**TCEQ DOCKET NO. 2024-1115-EAQ  
PROGRAM ID NO. 13001906**

**IN THE MATTER OF THE  
APPROVAL OF A WATER  
POLLUTION ABATEMENT PLAN  
BY VULCAN CONSTRUCTION  
MATERIALS, LLC**

**INDIVIDUAL LANDOWNERS' MOTION TO OVERTURN  
EXECUTIVE DIRECTOR'S DECISION**

**Figure 3, Water Elevation in Wells Near Vulcan<sup>31</sup>**

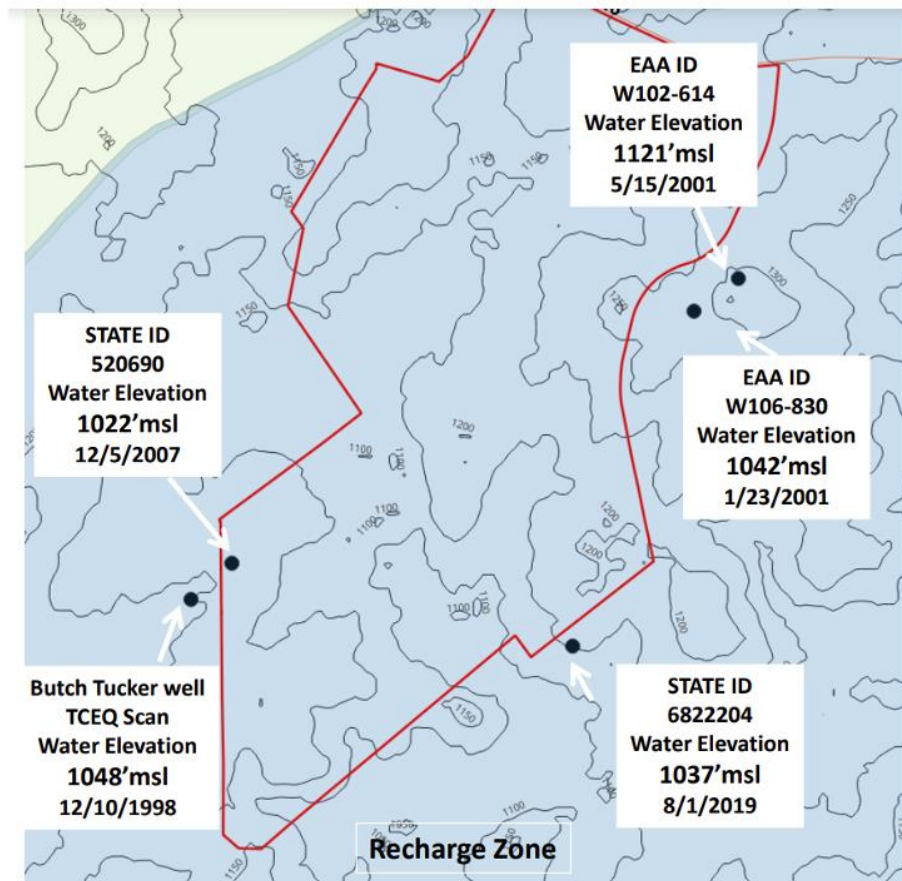
In fact, available water level data from several wells within 600 ft of the Vulcan property boundary shows water levels greater than 1022 ft-msl. *See* Figures 3 and 4 below.

Dr. Smith, along with geologist Dr. Jim Doyle, found that this data demonstrates that the proposed 1047 ft-msl mining floor may lead to increased infiltration of contaminants to the Edwards Aquifer.<sup>33</sup> The aquifer level at any point in time will be determined by a combination of water recharge and withdrawal. Because the water level in this area has exceeded the 1022 ft-msl level four times in 21 years, there is no reason to think it will not happen again over the expected 65 to 90-year life of the quarry.<sup>34</sup> In the period from 1990 to 2024, the 25 ft standoff approved by the Executive Director would

Figure 9. Schematic cross section with estimated topography after mining and water levels based on available data (J. Finneran, personal communication, April 16, 2024).

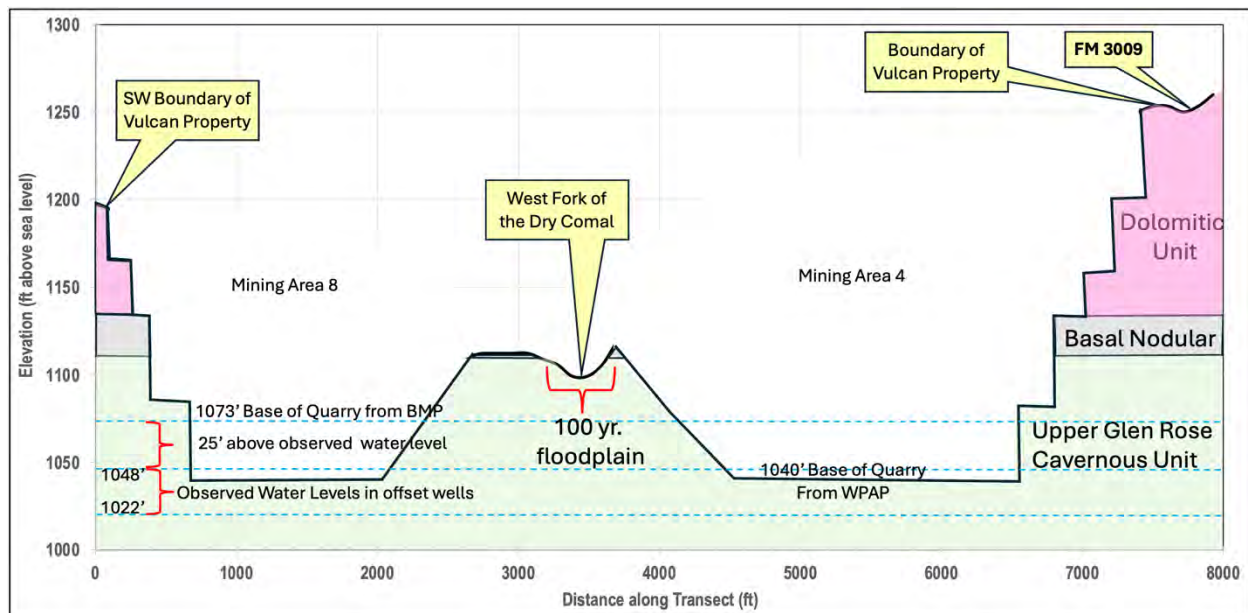
The WPAP (Pape-Dawson Engineers, 2024) for the site states that the mining areas will not be mined below an elevation of 1040 ft msl. According to the WPAP, this level of the quarry bottom will provide a 25-ft buffer above the high water level of the aquifer. A review of available water-level data indicates that at times, the bottom of the quarry will be flooded by the underlying aquifer (Figure 9). Water-level data from five wells close to the perimeter of the quarry boundary were evaluated to estimate expected water levels beneath the quarry and proposed depths of the excavations (Appendix B) (J. Finneran, personal communication, April 16, 2024). The White #4 well (#520690) had a water level of 1022 ft-msl on 12/5/07. At this water level plus the 25-ft buffer, the bottom of the quarry would be out of compliance. Another well (Tucker, EAA #Wxxx-137) had a water level of 1048 ft on 12/14/98. At this water level, the bottom of the quarry would be 8 ft below the water level in the aquifer.

**Figure 1**

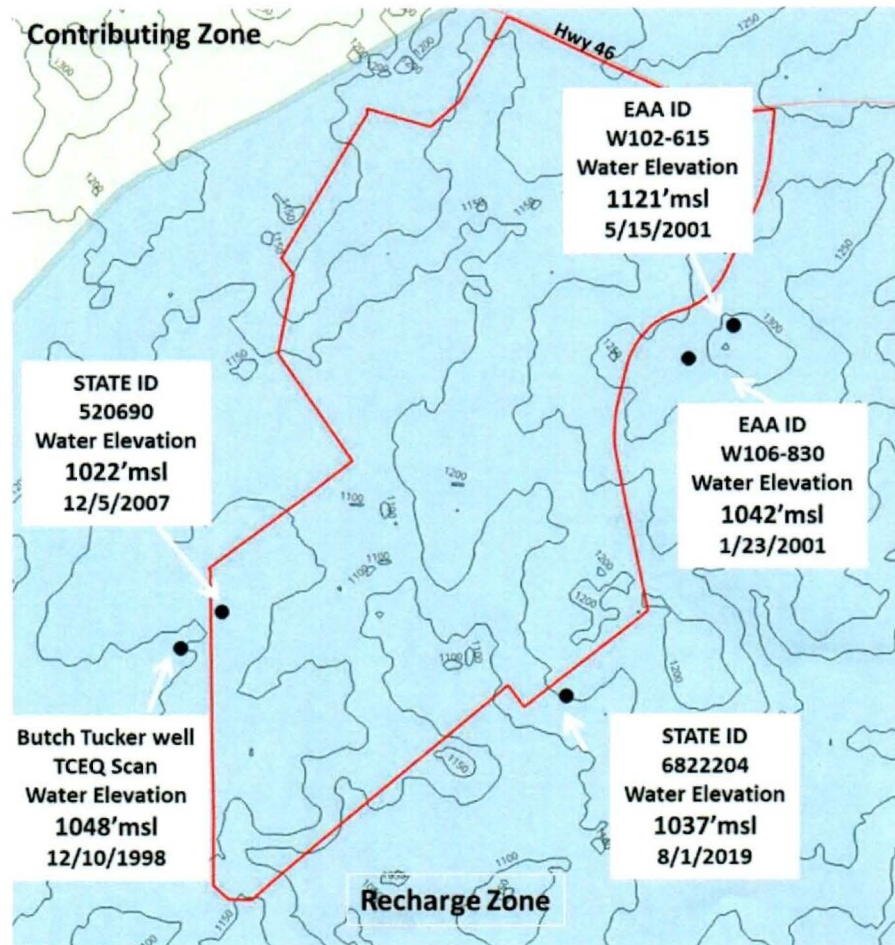
5. During my review of Vulcan's WPAP, I analyzed the separation distance between the floor of the quarry and groundwater. The amended Application states that the Mining Areas will not be mined below 1047 feet-msl. I found that water level data from the Texas Water Development Board from several wells within 600 feet of the Vulcan property boundary shows water levels greater than 1022 ft-msl. I prepared a map showing the location of those wells which is labeled as **Figure 1**, below:

1. The map demonstrates that the proposed 1047 ft-msl mining floor may lead to increased infiltration of contaminants to the Edwards Aquifer. Because the water level has exceeded the 1022 ft-msl level four times in 21 years, there is no reason to think it will not happen again over the expected 65 to 90-year life of the quarry. If the quarry permit had been granted as written in 1990 instead of 2024, the 25 ft standoff approved by the TCEQ-EAPP would have been violated four times in the period from 1990 to 2020. Also, the Vulcan quarry floor would have been flooded twice, directly contributing pollutants to the Edwards Aquifer.

Figure 3. Abundant caves indicate the sensitivity of the area, and along with the density of karst feature mapped directly across highway 46 contrasts with the density of features mapped in the Vulcan site assessment.

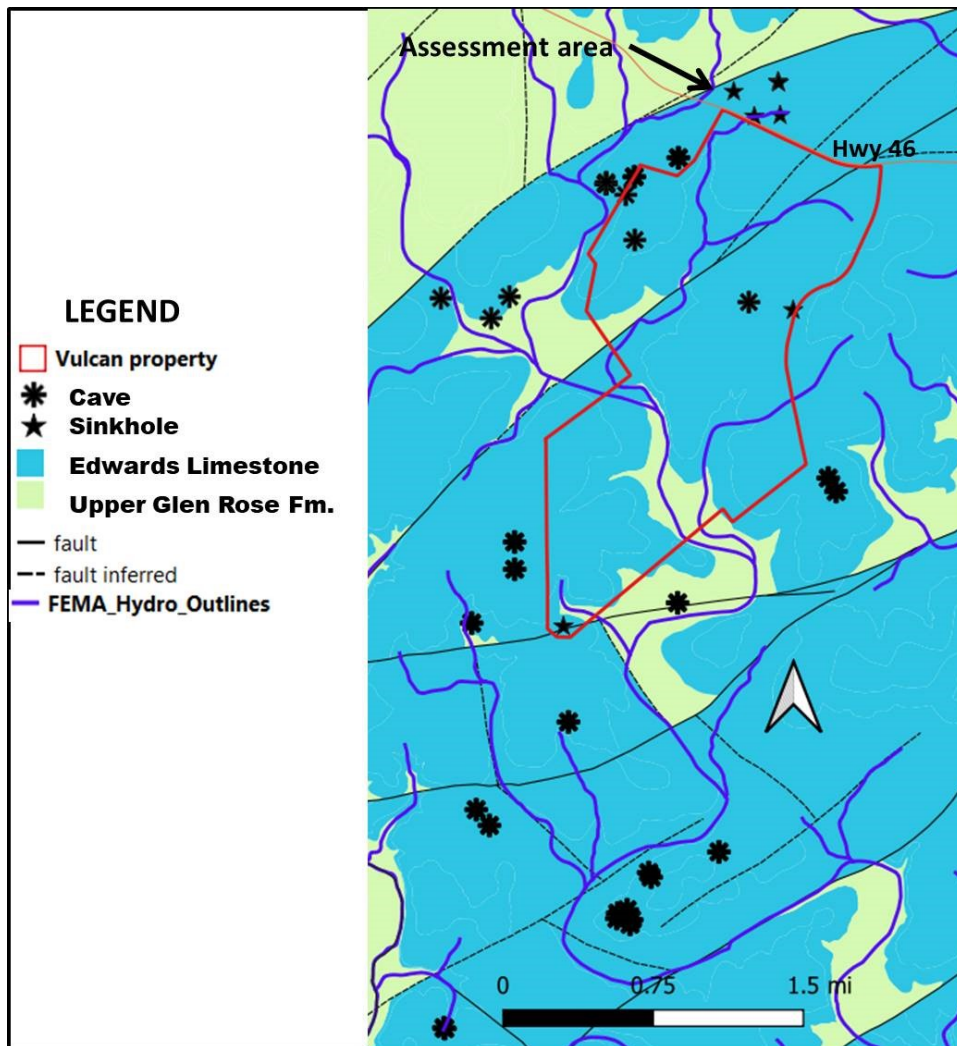
The site chosen for the Vulcan Comal Quarry is especially unsuitable for a quarry. Despite the claim in the WPAP that there is low potential for fluid migration into the aquifer, the abundance of caves in the vicinity show the area to be sensitive (Figure 3). Also, it should be noted that there is a subjective aspect to identifying sensitive features. The contrast in the density of features recorded at the Vulcan site and those recorded in a site assessment for a much smaller area directly on the other side of highway 46 suggests sensitive features on the Vulcan site may be undercounted.

Vulcan has indicated they do not intend to observe this BMP. The quarry site has an abundance of wells that could be used to establish a maximum expected level for the aquifer. Instead of using the well data,

Figure 4. One observed water elevation on the Vulcan property and four within a few hundred feet of the property demonstrate that the water levels in the area repeatedly reach elevations that would put Vulcan's desired elevation for the base of the quarry in violation of the TCEQ BMP.

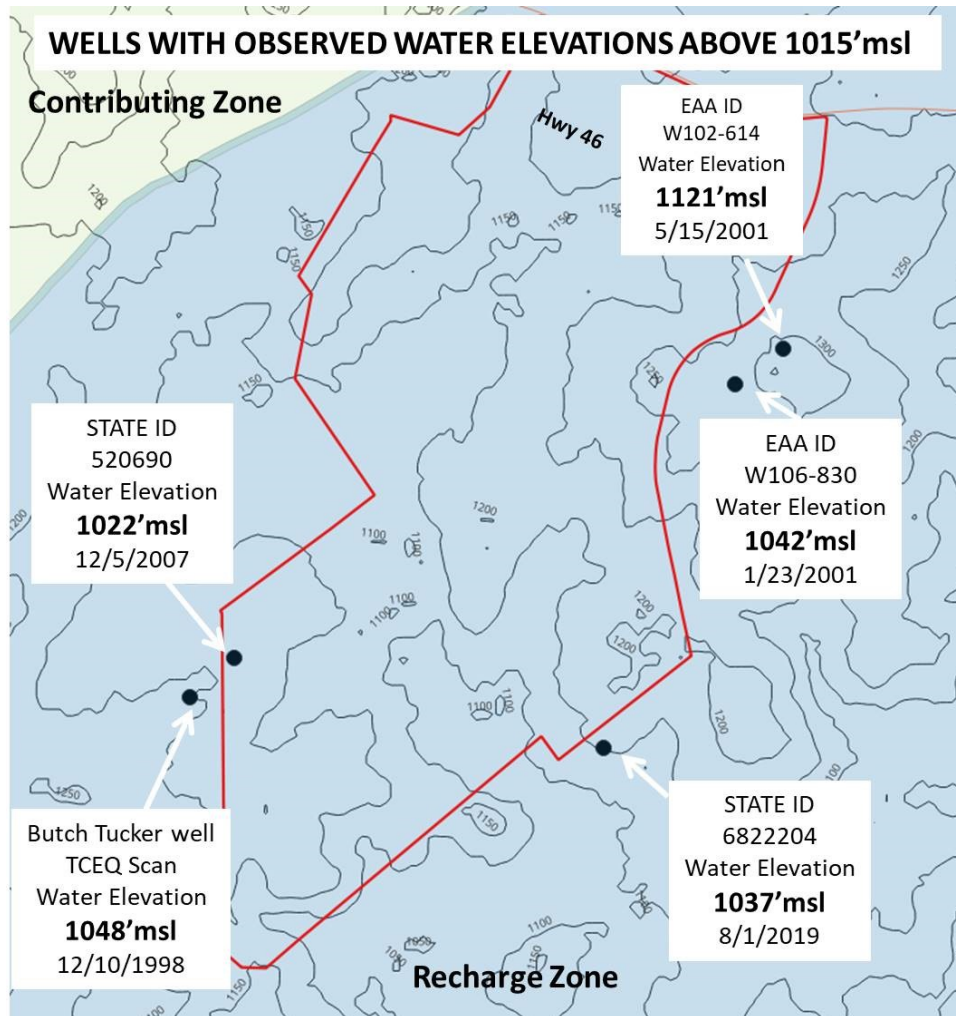
Vulcan has indicated a desired depth of 1040' msl to which they will excavate. They justify ignoring the BMP stating (without basis) that they know how the water elevation will change over the next 5-10 years and making the absurd claim that monitoring wells during excavation will tell them the highest level that the aquifer can reach. Since the WPAP calls for mining 956 acres in 10 to 15 acre annual increments, their monitoring program would have to be predictive of aquifer level changes resulting from

varying precipitation for the next 64-96 years. For the 1040' msl quarry base to be compliance with the TCEQ BMP, the highest elevation expected for the aquifer would have to be no higher than 1015' msl. In fact, five wells already drilled on or within several hundred feet of the property document different times over a 21 year span when a 1040' msl quarry base would have violated the TCEQ BMP (Figure 4). Three of those wells the recorded aquifer elevations above 1040' msl. Well monitoring would have value if its purpose is to monitor contaminant concentrations. Water level monitoring might allow mining activity to stop when level approaches 1015' msl, but if the 1040' msl level has already been reached in parts of the quarry, those areas will flood. The only thing that can be stated factually is that if Vulcan had been allowed to start this project in 1990 we would have already seen the quarry floor in excavated areas flood three times. Each time would bring the aquifer directly into contact with nitrate and other contaminants accumulated there. It is unlikely that the five wells drilled at random dates have actually identified the maximum possible elevation, and there is no reason to think the aquifer will not

reach the observed levels again. In TCEQ RG-500, the stated purpose of the BMP for the minimum quarry floor elevation is to establish the maximum level the aquifer might reach which "requires a preliminary estimate of the high-water level at the site", and to limit the quarry floor to 25' above that. While the BMP allows the use of a single well to establish the maximum expected aquifer level, the intent clearly is not to choose a minimum elevation from candidate wells. To really avoid causing harm to the aquifer, the
